# NOTES AND ERRATA

**POWER PLUG  
(LOOKING AT SCREWS)**

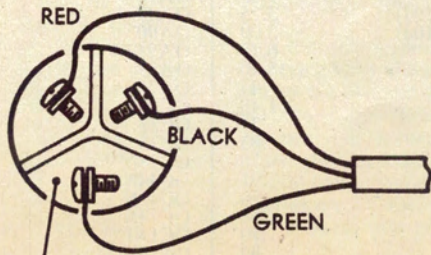
**LOW COST STEREO SYSTEM:** (January 1972, File No 1 / SA / 38). Several readers have commented on the diagram on page 39, querying the connection of the

active and neutral leads to the three pin plug. Contrary to what some readers apparently believe, there is strictly no regulation requiring that the active, neutral, or earthing conductors be connected to a plug or socket in any specific order. All that exists is a recommendation that the pins be wired in the order earth, active, neutral, in a clockwise direction, when viewed from the front of the socket. In practice, this convention will have been followed in the vast majority of installations. Since the wiring we showed does not conform to it, the black and red leads should be transposed, as shown.
